In the Drawings

REMARKS

The Office Action mailed May 17, 2006 has been carefully considered. Reconsideration in view of the following remarks is respectfully requested.

FIG. 2

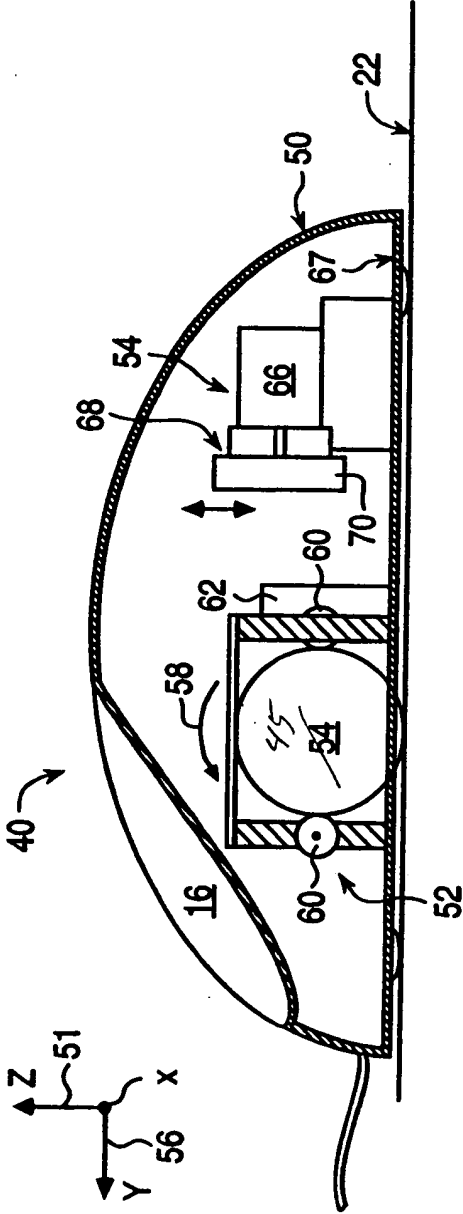
FIG. 2 has been amended to change the reference designation of the trackball to “45,” consistent with the specification.

FIG. 2 has been amended to change the reference designation of the trackball to "45," consistent with the specification.

The specification has been amended on page 11 in order to be consistent with the correction to FIG. 2, in which the reference numeral of the trackball has been changed "45" for consistency with the remainder of the specification.
